MANDATORY SERVICE BULLETIN

DATE: March 8, 2012 Service Bulletin No. 602
Engineering Aspects are
FAA Approved

SUBJECT: Incorrect Part Numbers on Service Instruction No. 1098G

MODELS AFFECTED: IO-540-AB1A5 or its applicable crankshaft that had propeller flange bushings replaced in the field in accordance with Service Instruction No. 1098G

Figure 2
Correct Part Number and
Location of Propeller Flange Bushings

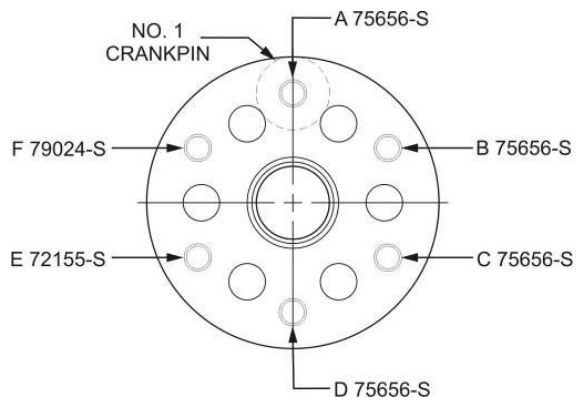
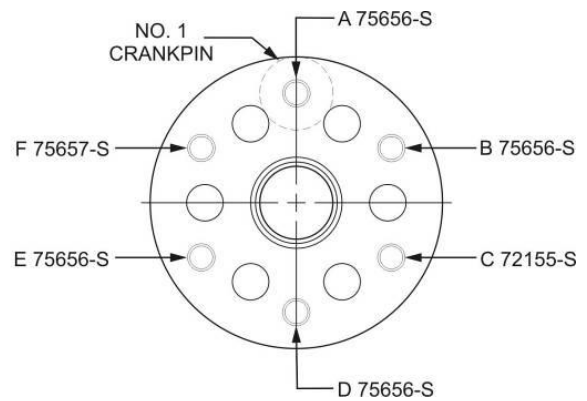
This Service Bulletin is notification that the propeller flange bushing part numbers for engine model IO-540-AB1A5 were misidentified in revision G of Service Instruction No. 1098. Service Instruction 1098 identifies part numbers for propeller flange bushings and the locations (A, B, C, D, E, and F) of where respective bushings are to be installed on the propeller flanges.

Figure 1 of this Service Bulletin shows the location of the propeller flange bushings as per Service Instruction 1098G (which is incorrect).

Figure 2 and the information below identify the correct propeller bushing part numbers and locations for the installation of propeller flange bushings on the IO-540-AB1A5 engine model.

1. Examine the bushings from the backside of the crankshaft flange to make sure that the bushings are not displaced (pushed back).
2. If any of the bushings are displaced, remove the propeller flange bushings.
3. Install the correct propeller flange bushings with the correct part number (Figure 2) in the corresponding locations.

- A. 75656-S
- B. 75656-S
- C. 72155-S
- D. 75656-S
- E. 75656-S
- F. 75657-S
